UNITED STATES PATENT AND TRADEMARK OFFICE

APPLICATION NO.	FILING DATE	FIRST NAMED INVENTOR	ATTORNEY DOCKET NO.	CONFIRMATION NO.
10/767,039	01/29/2004	Toshiharu Furukawa	ROC920030272US1	4826
30206	7590	02/09/2006	EXAMINER	
IBM CORPORATION ROCHESTER IP LAW DEPT. 917 3605 HIGHWAY 52 NORTH ROCHESTER, MN 55901-7829			CAO, PHAT X	
			ART UNIT	PAPER NUMBER
			2814

Office Action Summary

DETAILED ACTION

**FIG. 5n**

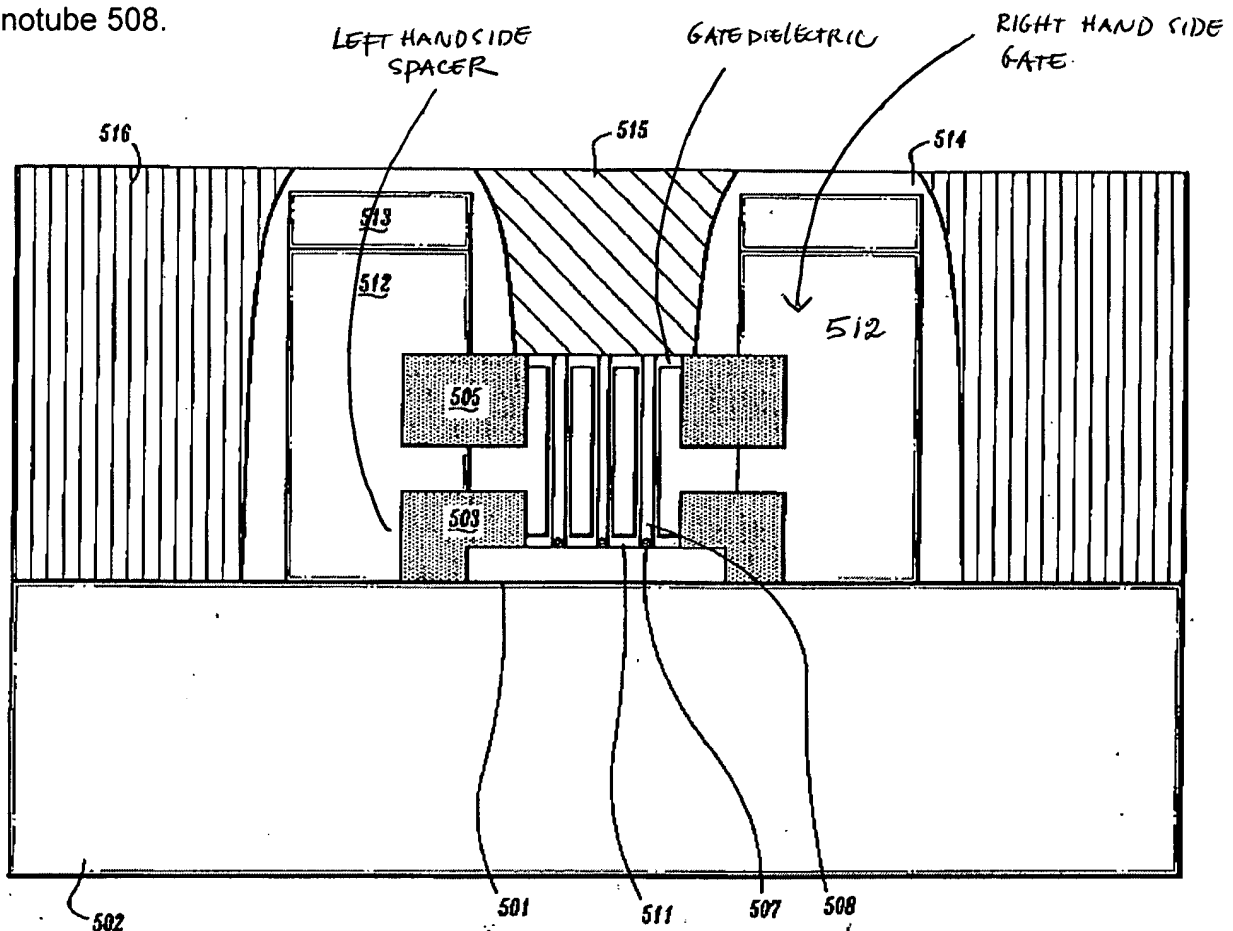
Regarding claims 1, 5 and 42, Appenzeller (Fig. 5n) discloses a vertical Semiconductor device structure, comprising: a substrate 502 defining a substantially horizontal plane; a gate electrode 512 on a right hand side (par. [0040], lines 19-20) projecting vertically from the substrate 502 and including a vertical sidewall; a spacer 503 on a left hand side of a dielectric material (par. [0038], lines 6-7) flanking the vertical sidewall and spaced horizontally from the vertical sidewall of the right hand side gate electrode 512 to define a vertical passage; a carbon semiconductor nanotube 508 (par. [0038], lines 1-3) positioned in the vertical passage and extending between opposite first and second ends with a substantially vertical orientation; a gate dielectric 511 (par. [0040], lines 13-14) disposed on the vertical sidewall between the

semiconductor nanotube 508 and the right hand side gate electrode 512; a source/drain 501 electrically coupled with the first end of the semiconductor nanotube 508; and a source/drain 515 electrically coupled with the second end of the semiconductor nanotube 508.

Regarding claims 2-3 and 9, Appenzeller (Fig. 5n) further discloses that the source/drain 501 is composed of a catalyst material (par. [0038], lines 1-6) effective for synthesizing the semiconductor nanotube 508, and the source/drain 501 is positioned on the substrate 502 in vertical alignment with the passage.

Regarding claim 8, Appenzeller (Fig. 5n) further discloses that the passage has a rectangular cross-sectional profile when viewed in a vertical direction.

Regarding claims 4, 10-11 and 44, Appenzeller (Fig. 5n) further discloses that the top portion of the spacer is vertically spaced relative to the substrate 502 to define a gap, the gap being filled by a bottom portion of the spacer 503.

Regarding claims 12-15 and 45, Appenzeller (Fig. 5n) further discloses a plurality of semiconductor nanotubes 508 positioned horizontally between the right hand side gate electrode 512 and the left hand side spacer 503, each of the plurality of nanotubes 508 extending vertically in the passage and having a first end electrically coupled with the source/drain 501 and the second end electrically coupled with the source/drain 515,

and an insulating material 511 filling space within the passage not occupied by the plurality of nanotubes 508.

Regarding claim 43-44, Appenzeller (Fig. 5n) also discloses that the top portion of spacer 503 is separated from the substrate 502 by a gap and the spacer 503 is separated from the sidewall by a passage, the nanotube 508 is positioned in the passage, and an insulating material comprising the spacer portion 503 (bottom portion) filling the gap and an insulating layer 511 filling portions of the passage unfilled by the nanotube 508.

Appenzeller does not disclose that the nanotube 508 has a vertical dimension greater than or equal to a vertical height of the gate electrode 512.
